SERVICE BULLETIN

DATE: 28 NOVEMBER 1986 PAGE 1 OF 7

SUBJECT: INSTALLATION OF FAILSAFE DEVICE AT TAIL ROTOR DRIVE SHAFT AFT FLEXIBLE COUPLING, P/N 369A5501 or 369H2564: AND INSPECTION OF FLEXIBLE COUPLINGS.

Figure 1. Installation of Failsafe Device, Aft Tail Rotor Coupling

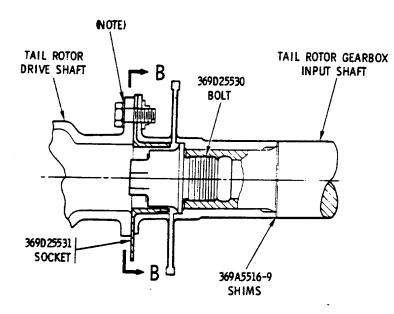
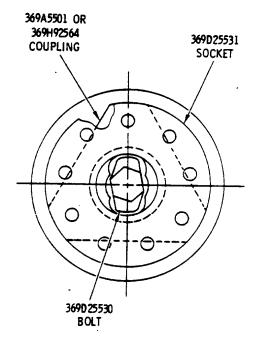
F. Install aft socket (P/N 369D25531) between tail rotor gearbox and tail rotor drive shaft as shown in Figure 1. Torque aft coupling tail rotor bolts to 80 to 100 inch pounds.

With tail rotor drive shaft removed, inspect flexible couplings per Section 9 HMI Vol. I. Also visually inspect forward and aft coupling bolts and sockets for indications of contact. Do not loosen or remove bolt. If signs of contact are noted, remove and reinstall socket and/or coupling bolt so that maximum clearance is obtained between bolt key and socket. (See View B-B, Figure 1.) Visually verify proper clearance before reinstalling tail rotor drive shaft.

NAS620C416L WASHER REPLACES EXISTING NAS620C416 WASHER, 3 PLACES

Figure 2. Stud and Insert - Typical Replacement

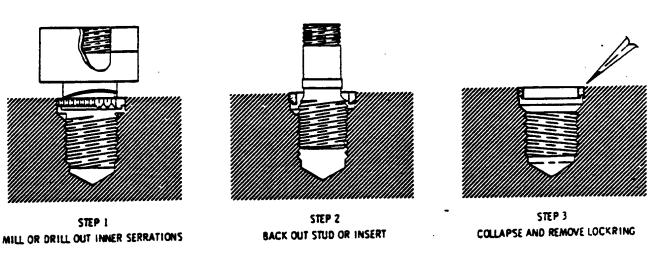
2) Using Rosan wrench (P/N R1105W) and removal tool (P/N SM101-18) remove existing studs as shown in Figure 2.

- 3) Install MS51992A803 -14 studs.
- 4) Repeat Step J.
